REVISED
 1770 CENTRE STREET
 LOT 3 OF LOT 4 OF LOT B
 OF SECTION 5, T1N, R8E, B1M
 RAPID CITY, PENNINGTON COUNTY, SOUTH DAKOTA

FINAL SITE
 PARKING / LANDSCAPING PLAN

PROJECT NO. 04-038 DRAWING NO.

C1.2

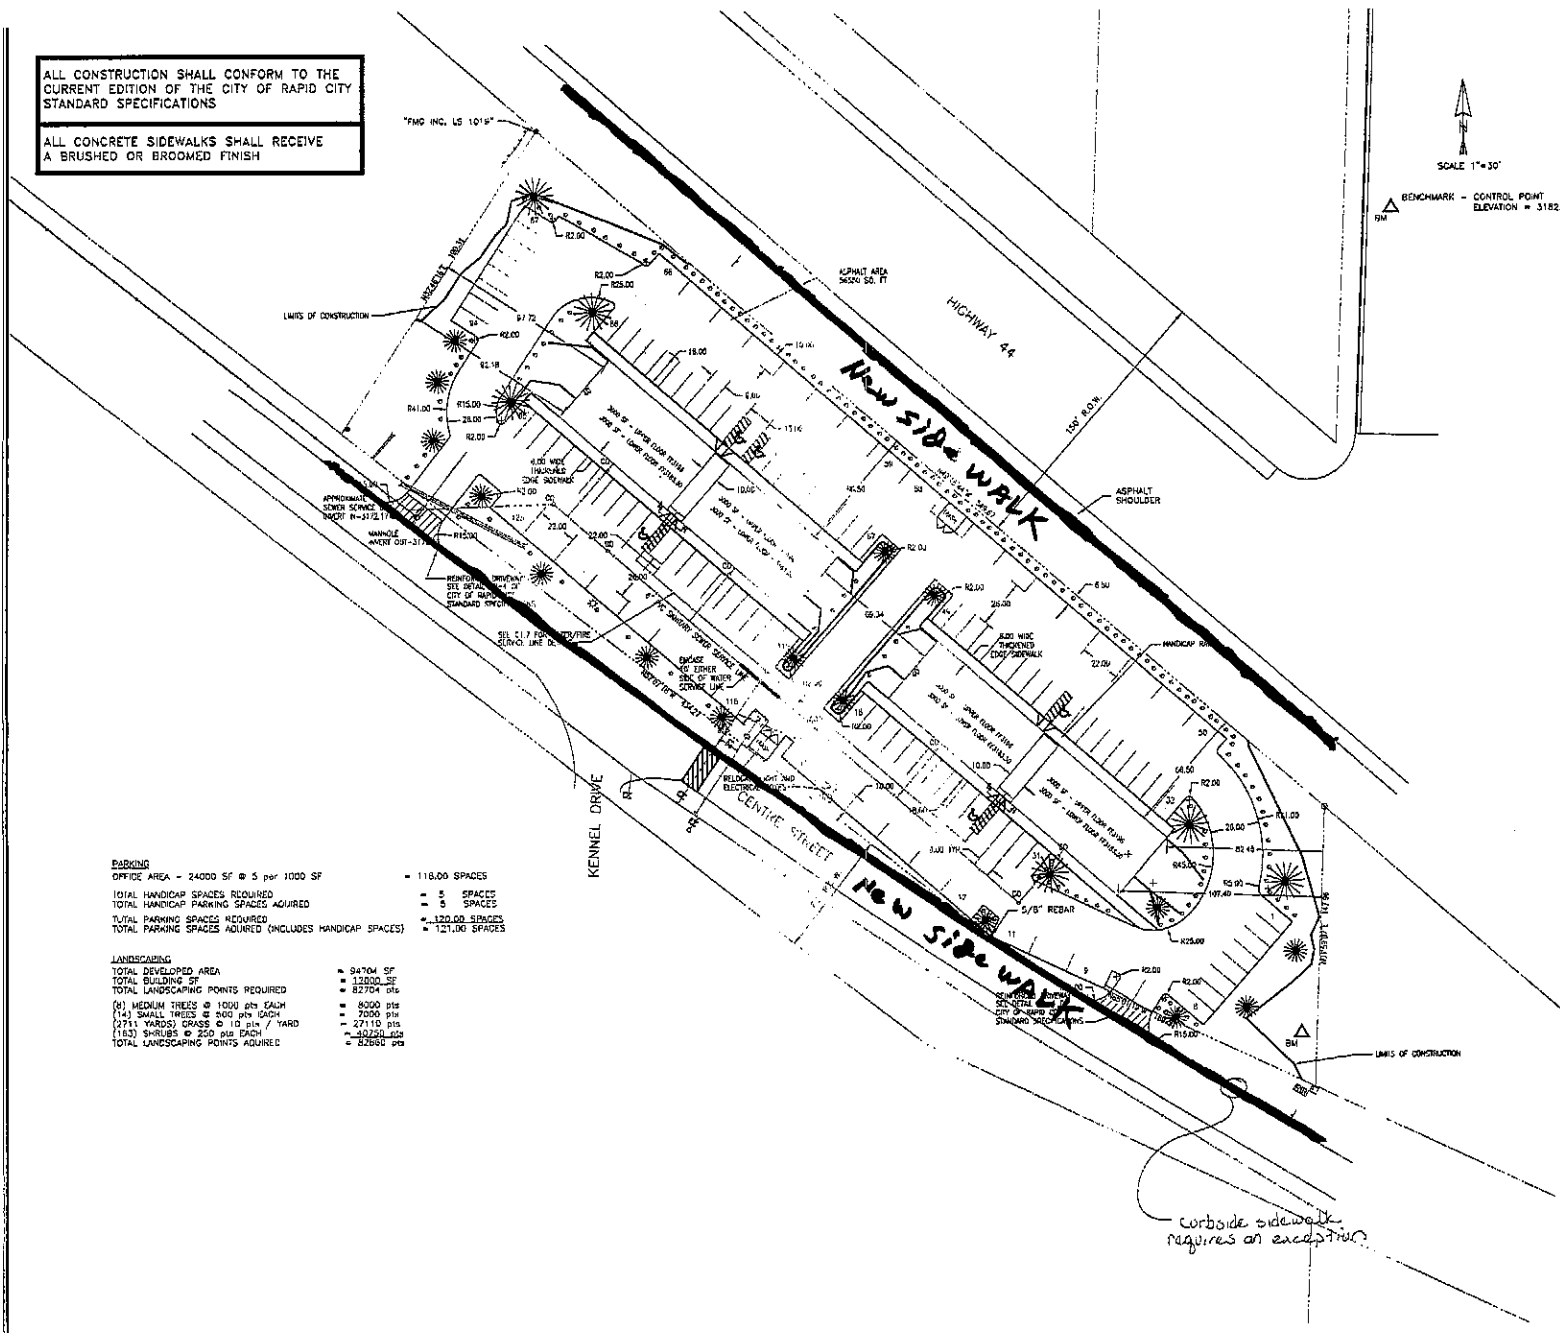
curbside sidewalk requires an exception
